## Addendum #1

Re: **Addendum No. 1**  
Cary Main EMS  
819 Kildaire Farm Road  
Cary, NC 27511  
ADW Job No. 21046  
Wake County Bid #24-086

These clarifications constitute Addendum No. 1 and considered part of the Bid Documents. General Contractor shall see that their sub-contractors are in full receipt of the information contained herein.

2 PLUMBING ROOF DRAIN LEADER RISER  
Scale: NONE

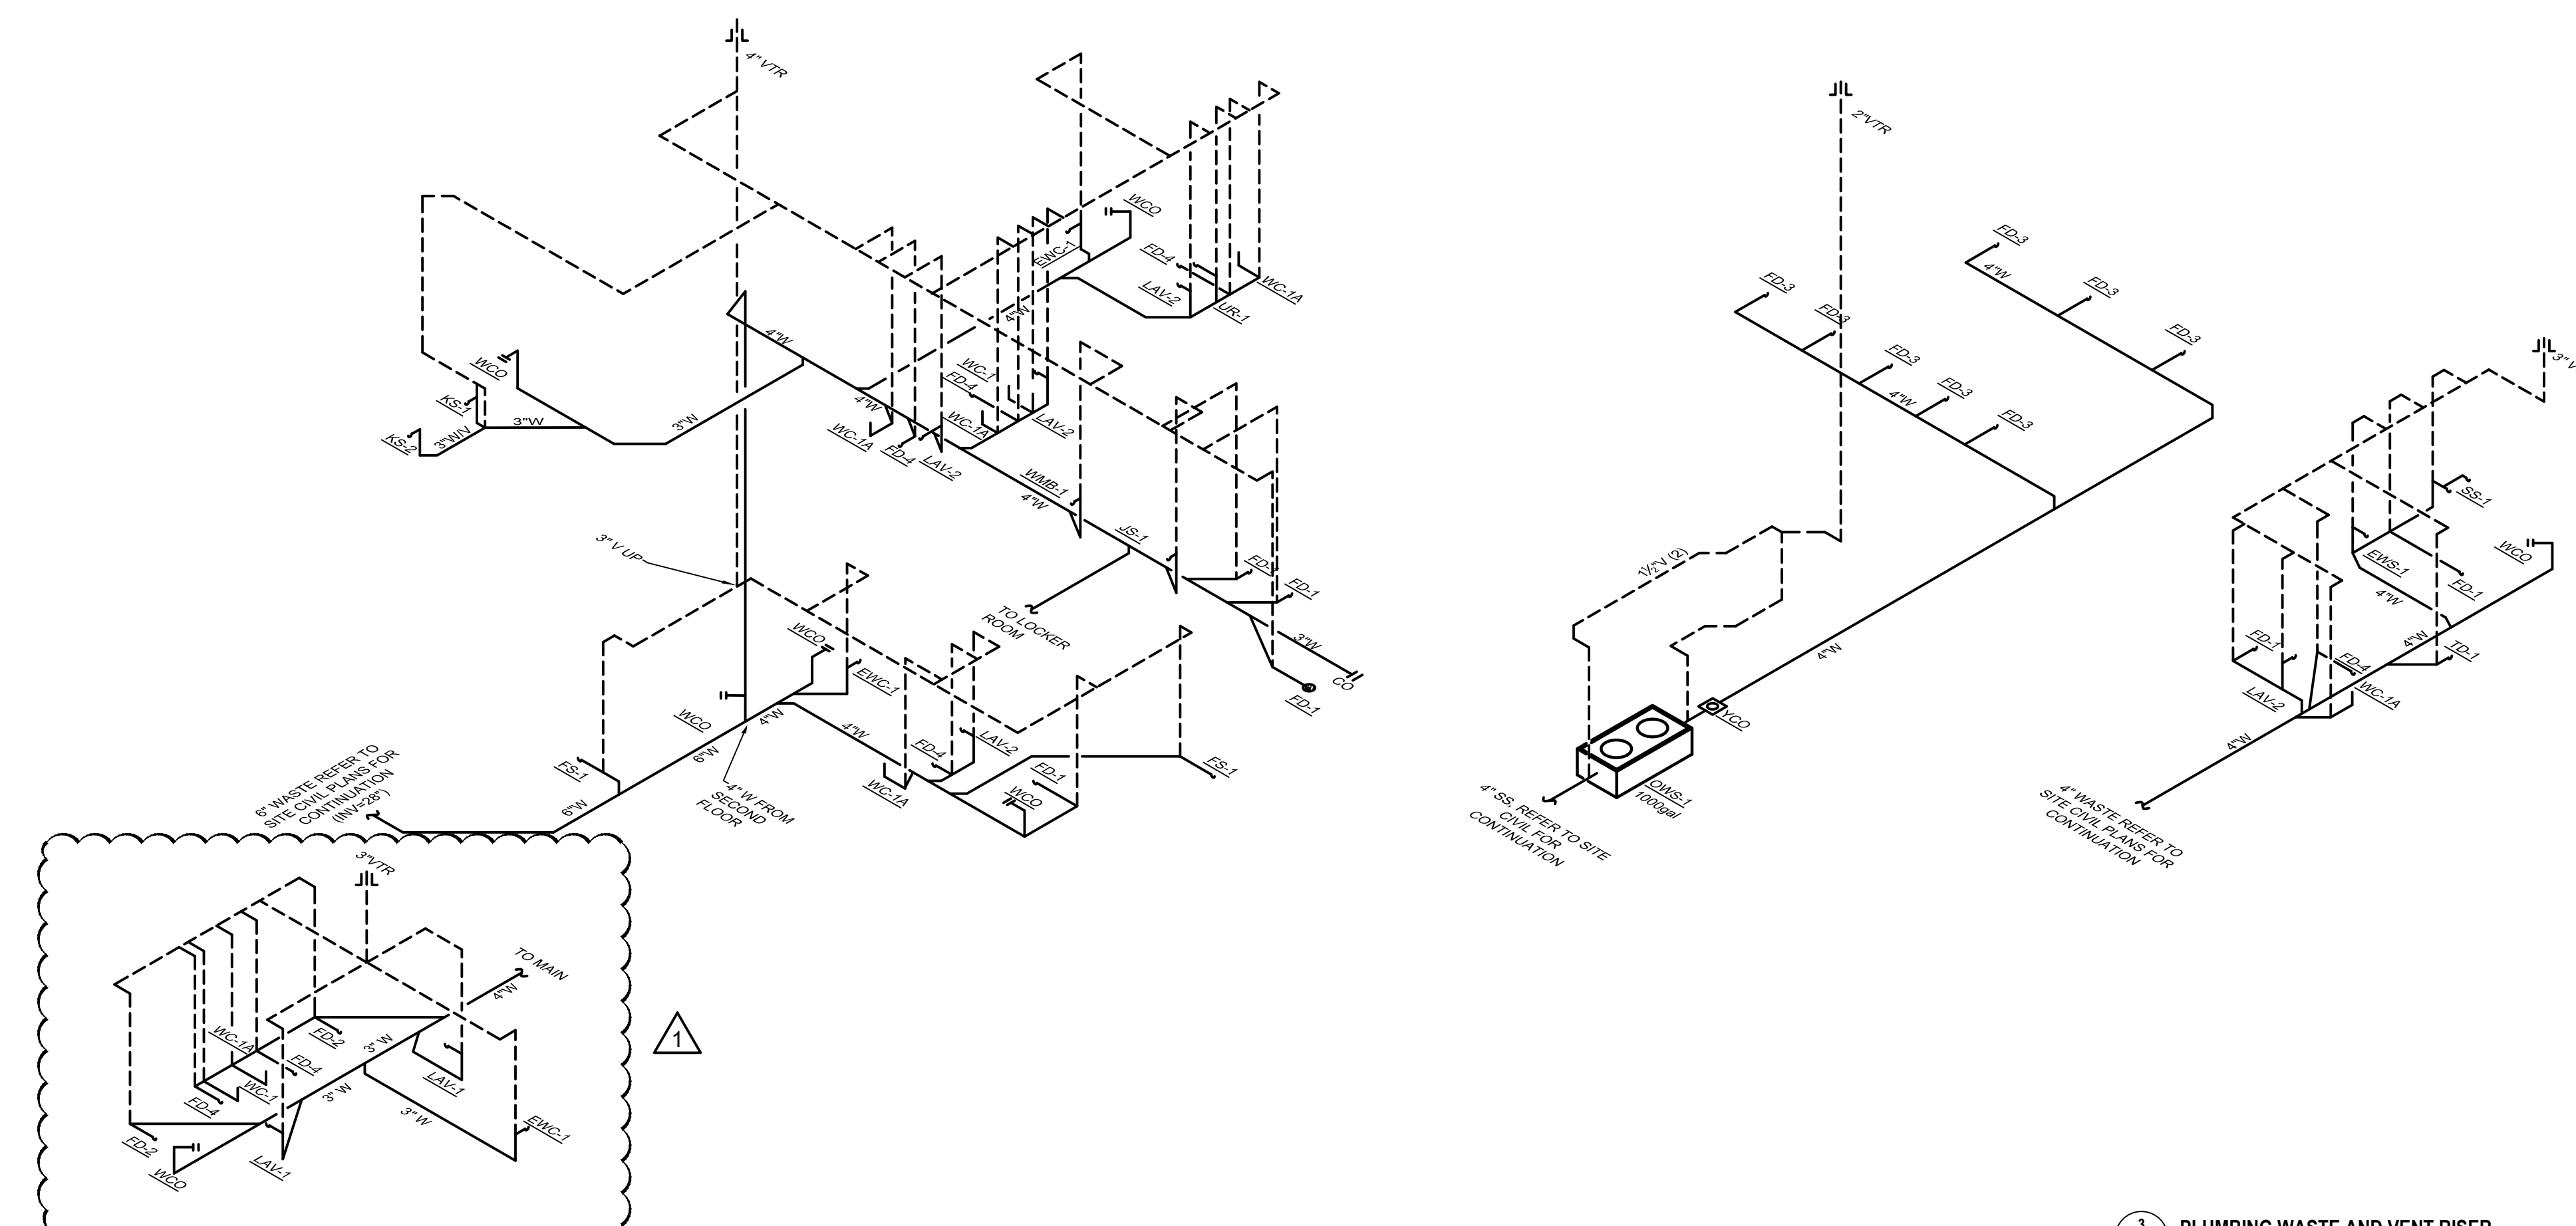
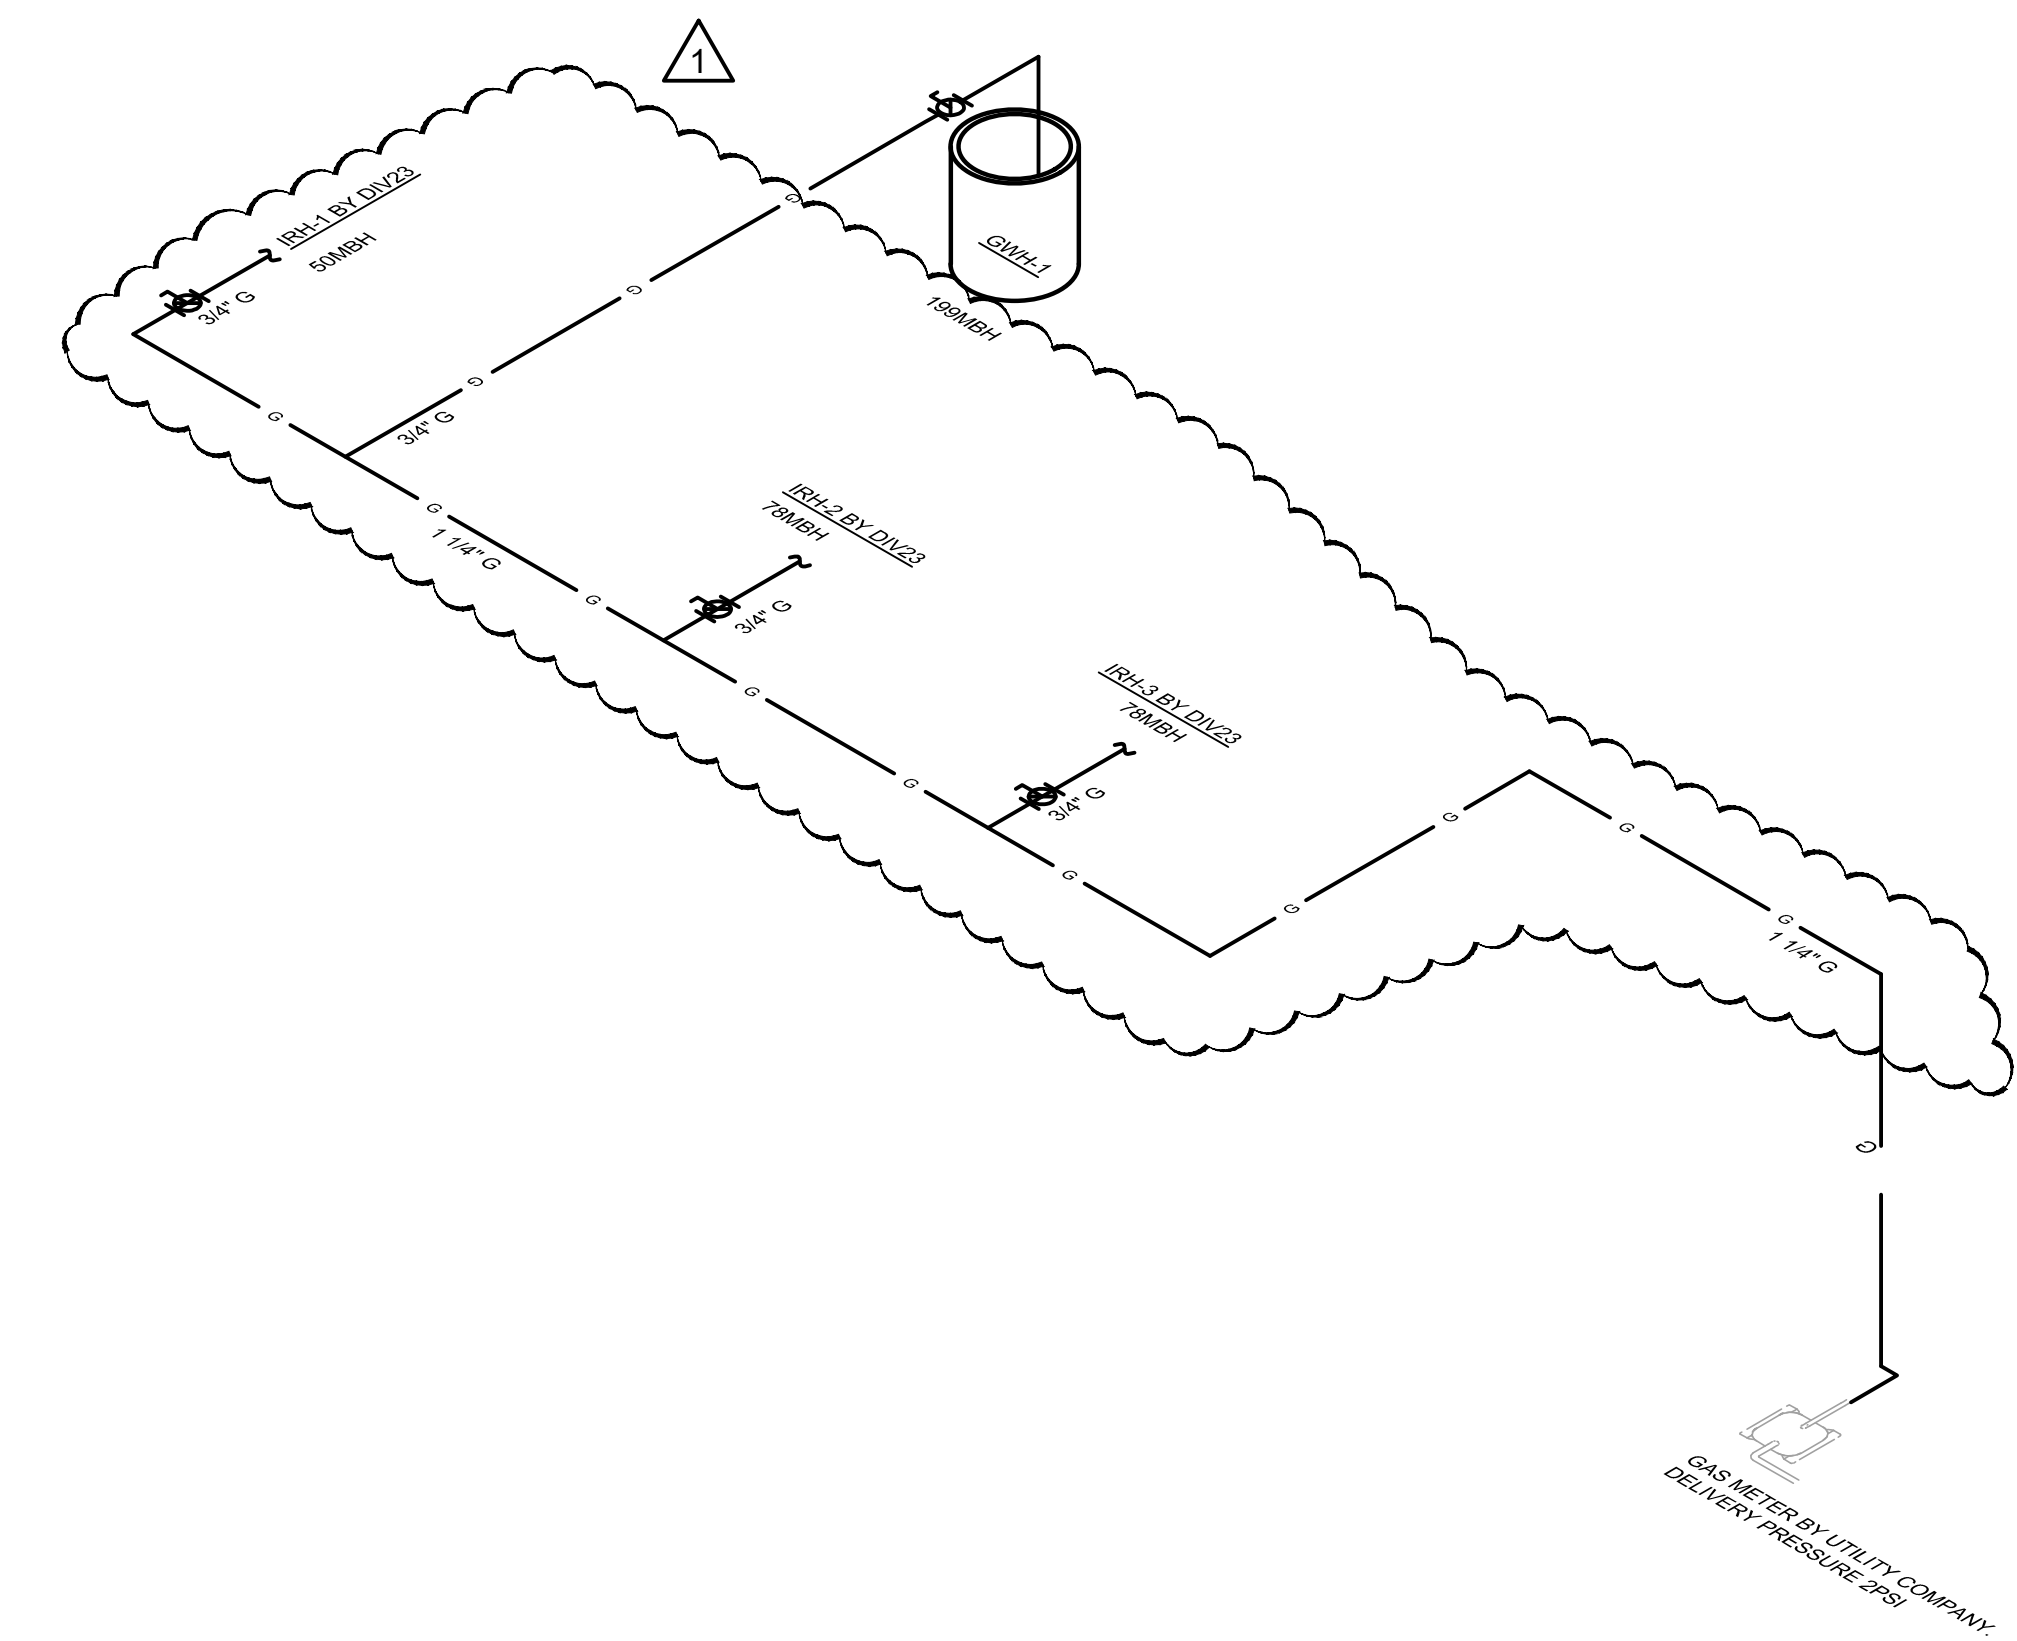
- 1.) Sheet P001: See attached revised sheet for gas load summary per permit comments.
- 2.) Sheet P201: See attached revised sheet for note regarding incoming water service, back flow preventer and PRV valve per permit comment.
- 3.) Sheet P210: See attached revised sheet for revisions to LAV-2 in Men 206. Roof square footage added to low roof area per permit comment.
- 4.) Sheet P200: See attached revised sheet for roof area drainage square feet per permit comment.
- 5.) Sheet P301: See attached revised sheet for updates to the riser diagrams per permit comment.

ELECTRICAL CONNECTIONS TO MECHANICAL EQUIP. NO SCALE 05

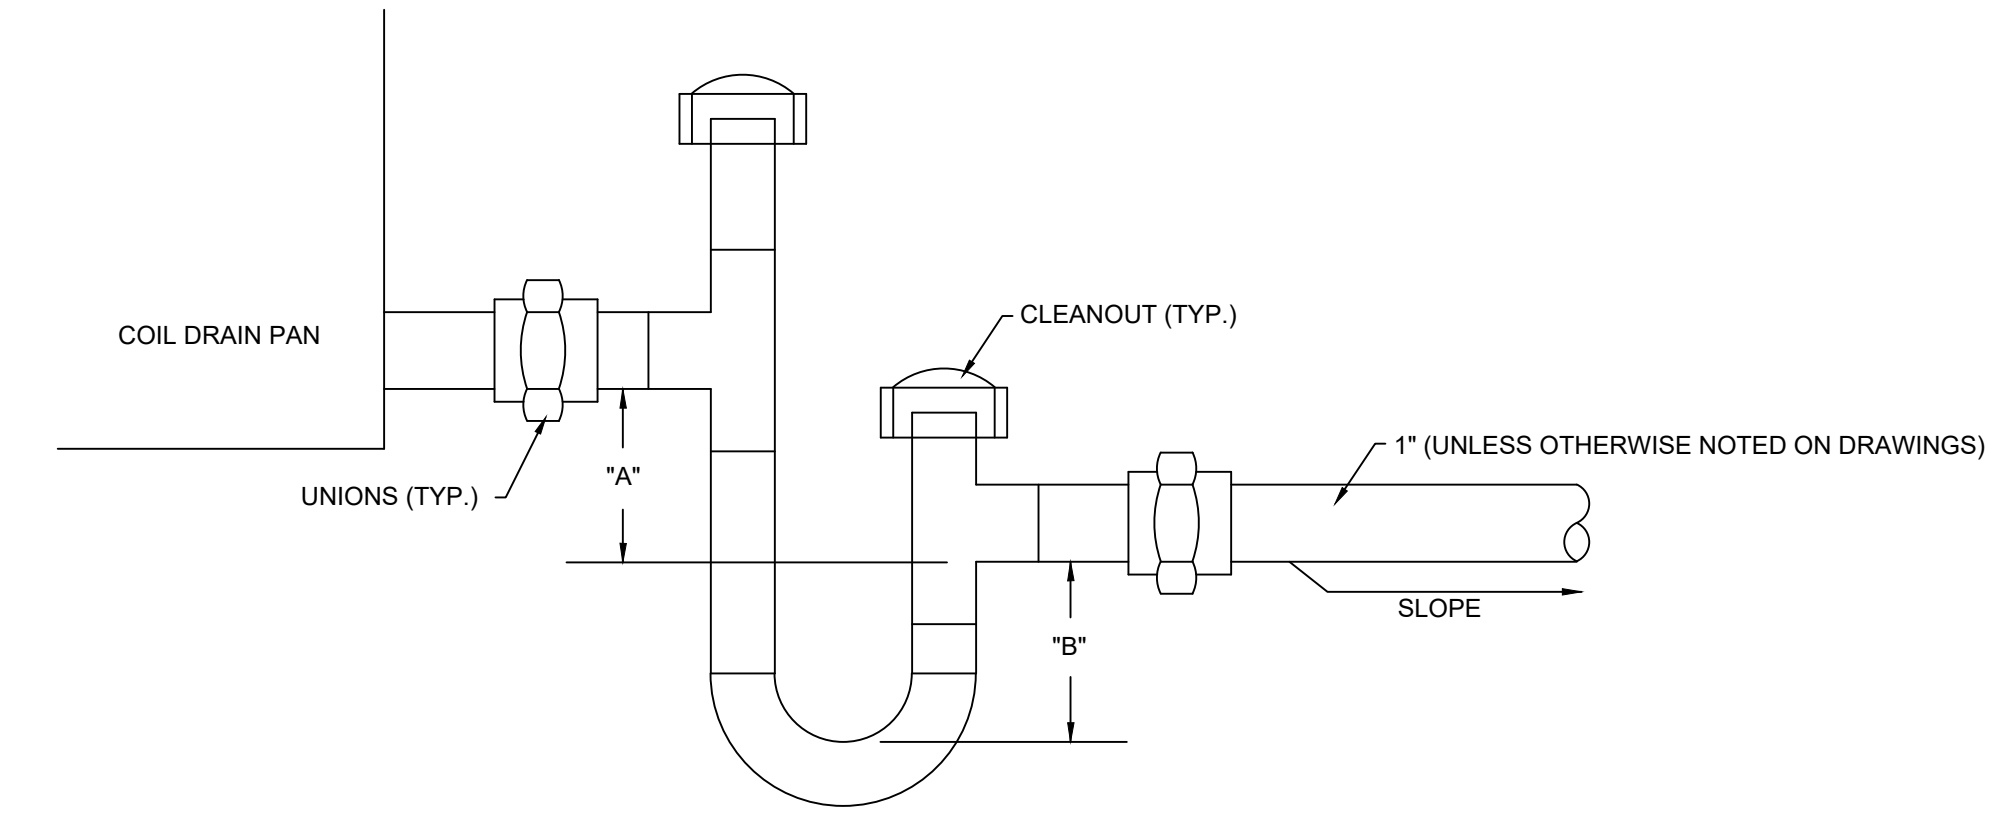
- 1.) Sheet M501: See attached revised sheet for revised note 2 on detail 05/M501 per permit comment.
